**Position paper**

**Ext. No 1393 / 24.08.2017**

Report on the Appropriate Assessment of the investment proposal for "IMPROVEMENT OF THE ROUTE OF LOT 3.2 OF STRUMA MOTORWAY" on the habitats and species protected and the conservation objectives of NATURA sites SCI BG0000366 "Kresna-Illindentsi" and SPA BG0002003 " Kresna "

3, Planned in the AAr existing (modified) and new underpasses for animals and their situation relative to the mapped in 2003 road sections.

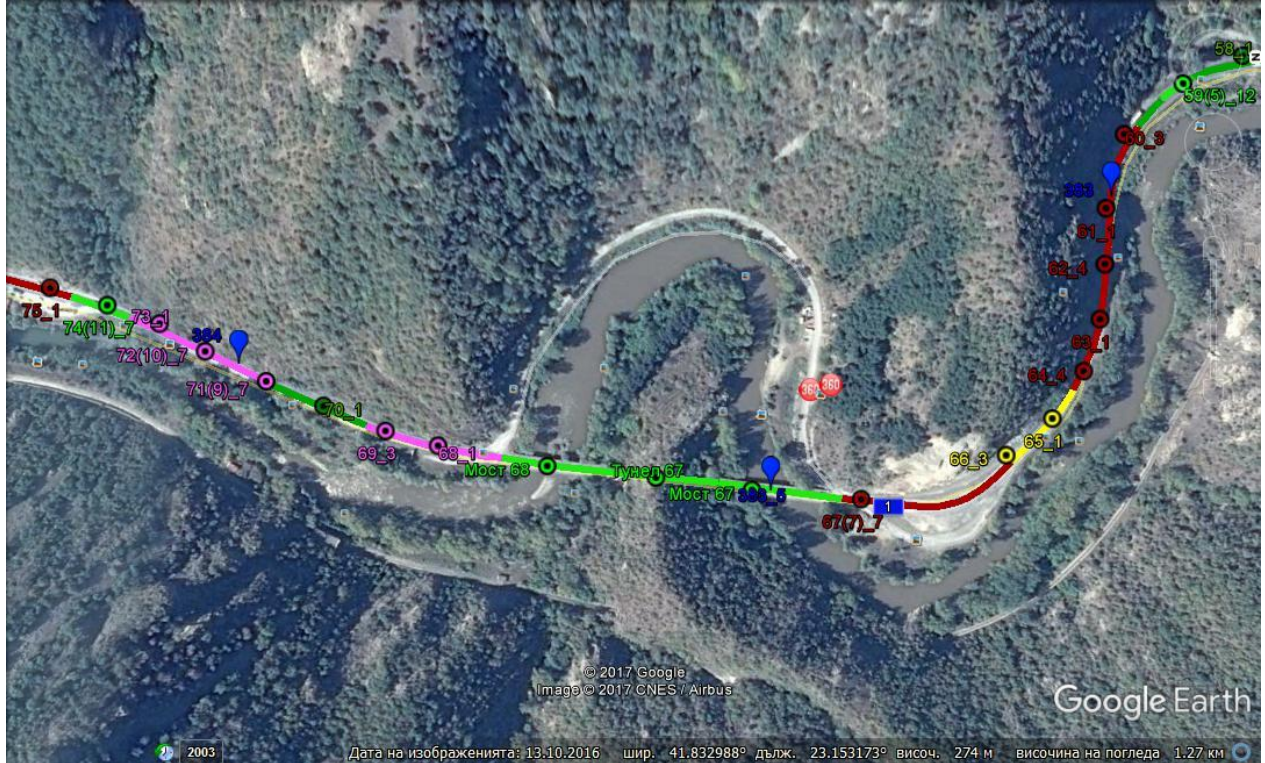
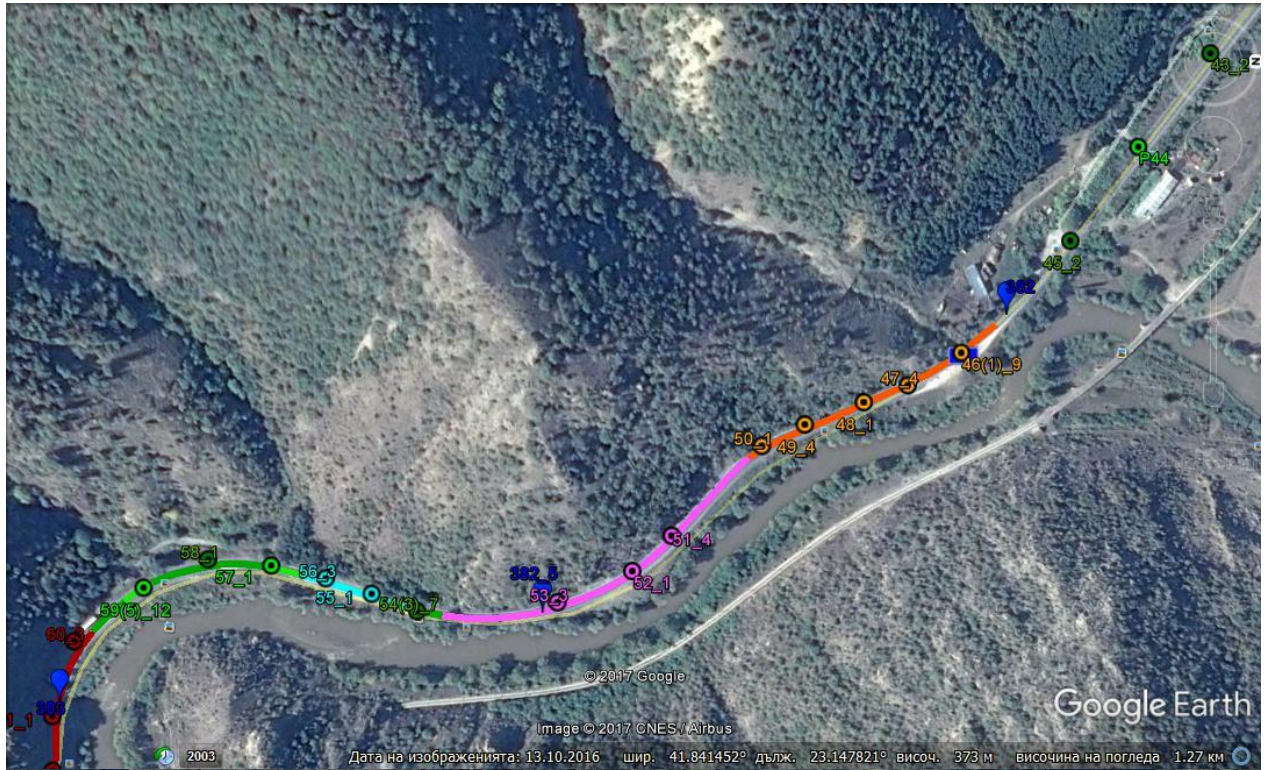
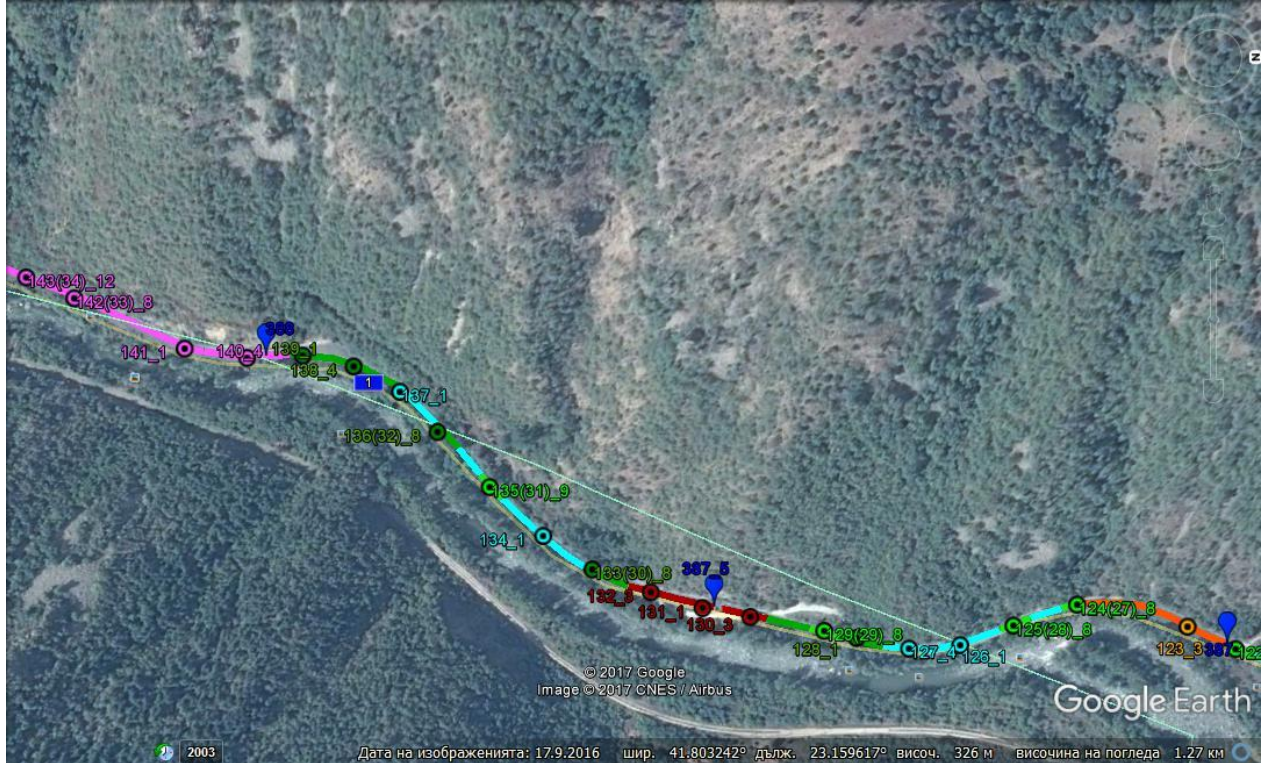
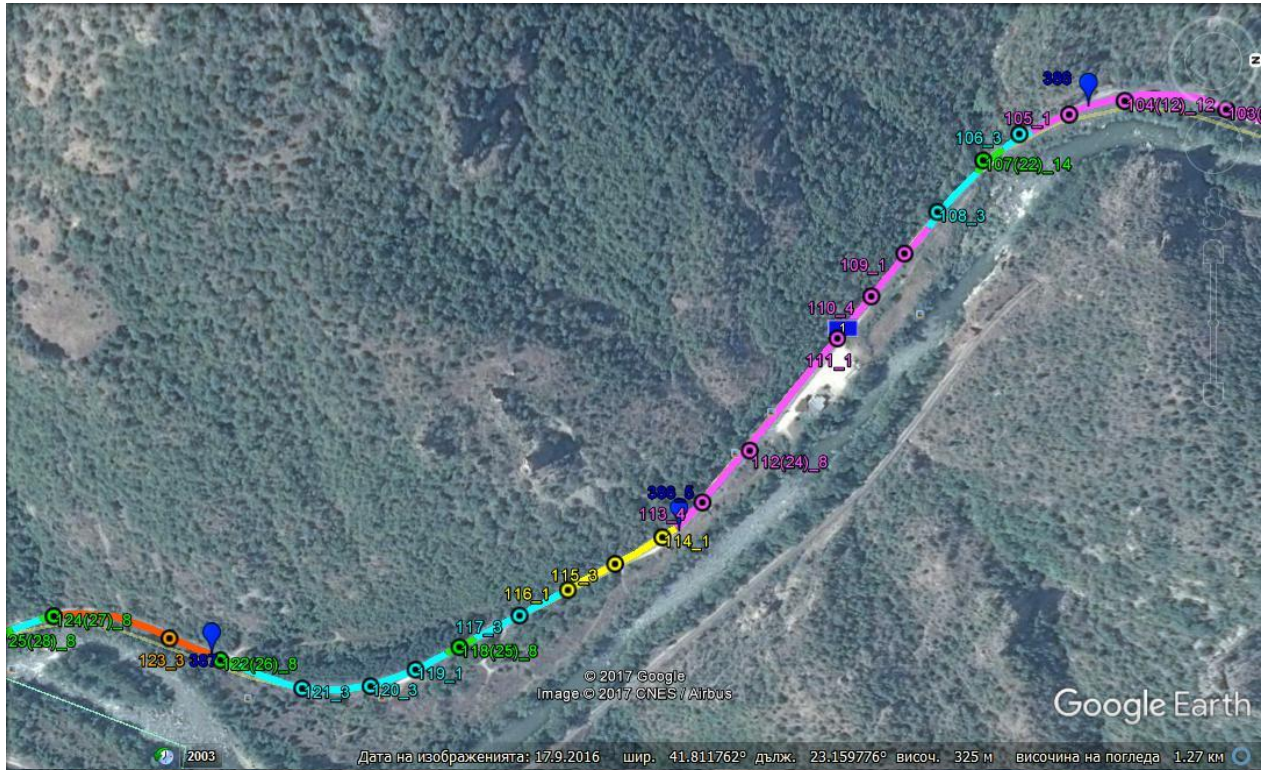
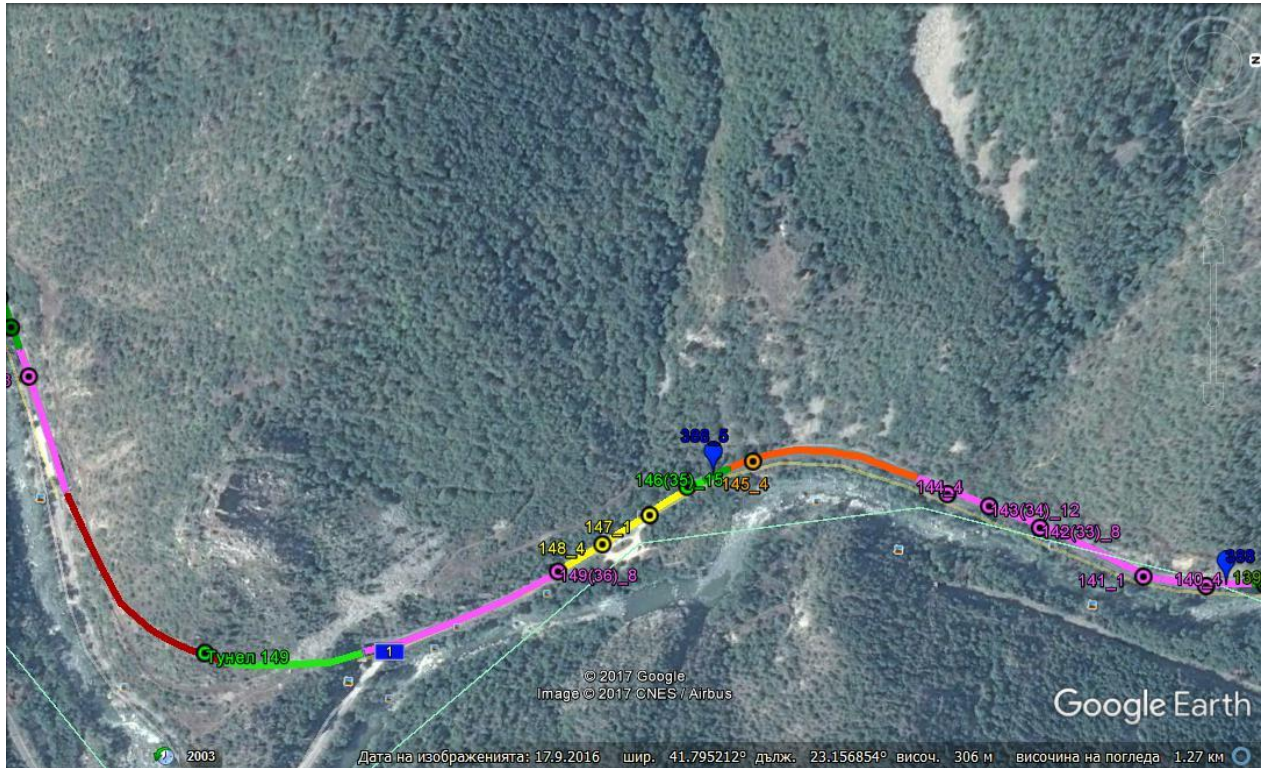
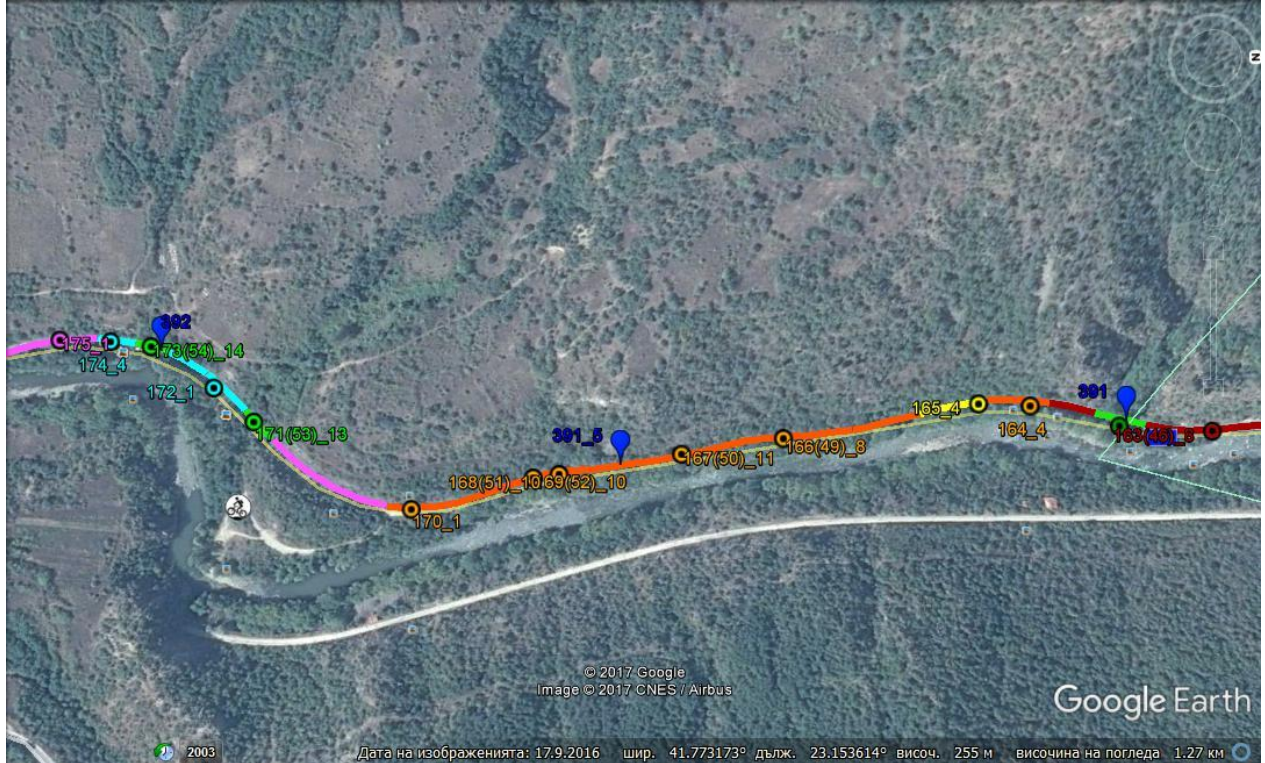
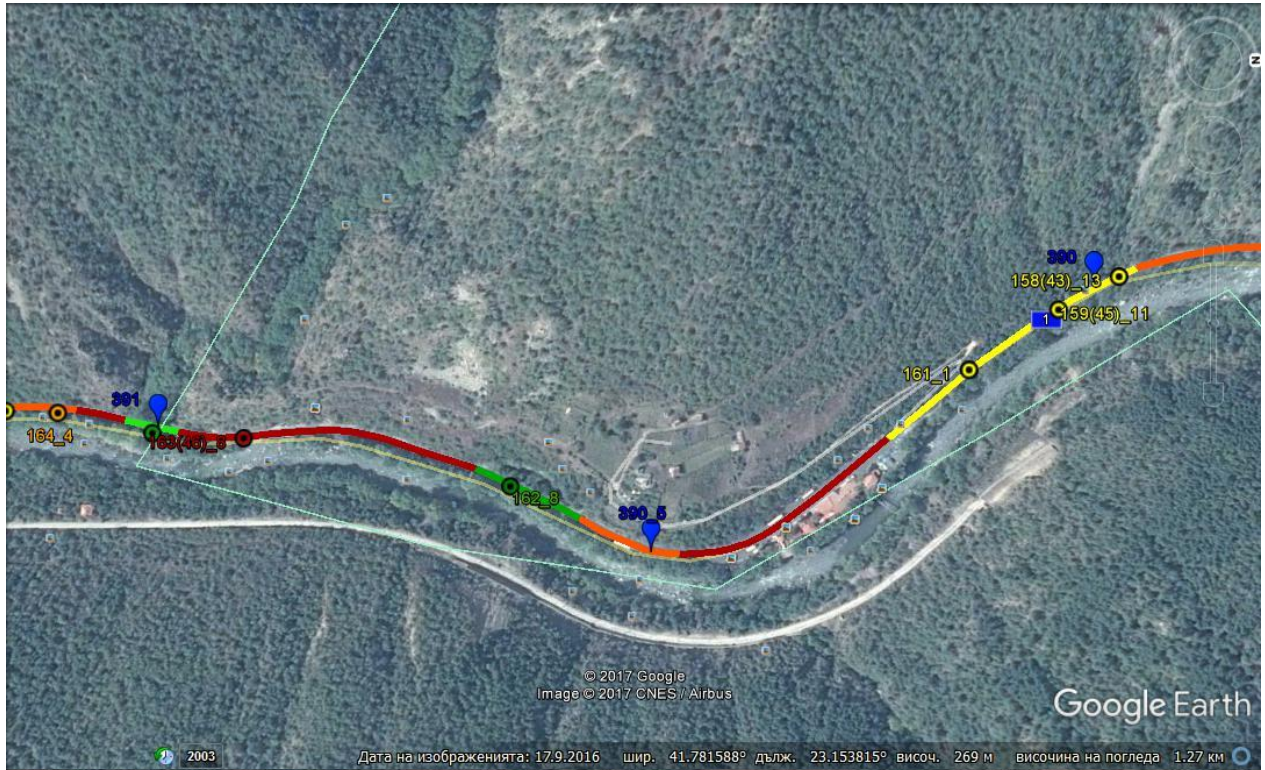
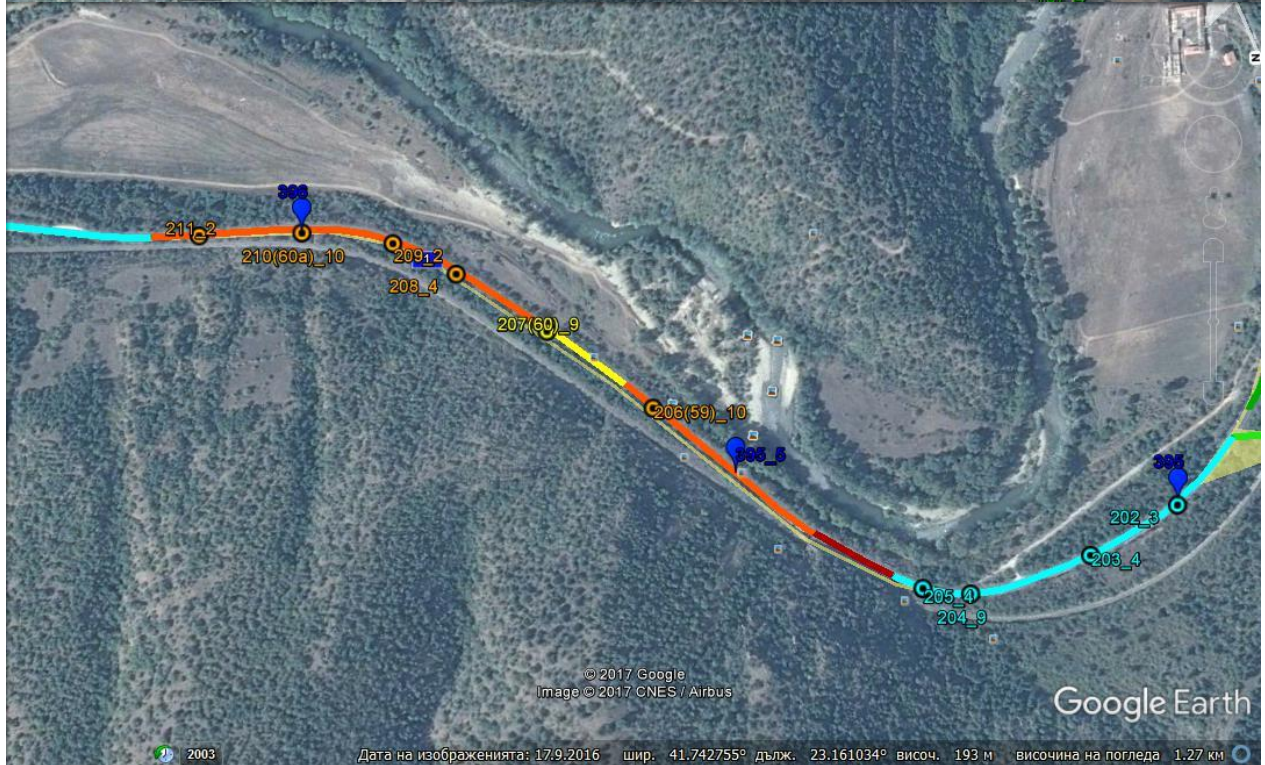
Here is presented an analysis of the situation of planned in AAr underpasses for animals in suitable or unsuitable for the purpose road sections. The underpasses have the following symbols: X(Y)\_Z – where X is number of the facility according to the table in Appendix in the AAr; Y is number of the existing facility according to the data base from the monitoring from year 2003; Z – kind or type of the facility as per the technical scheme in Appendix 8 of AAr. The facilities are grouped in road sections (see item 1) as follows:

From a total of 167 facilities in NATURA site BG0000366 and the section of Kresna Gorge, 120 (72%) are planned in unsuitable sections and will not be effective and functional – or will lead to additional fragmentation and steep inaccessible for the animals batters or in other 24 (14.4%) of them will damage valuable natural habitats.

Below are presented maps of these facilities according the kilometers given in appendix 8 of the AAr. The colors of the road sections and their respective facilities are designated as follows: A – dark red; B – orange; C1 – yellow; C2 – lilac; D- light blue; E – dark green; F – light green. The kilometers are presented in dark blue arrows.
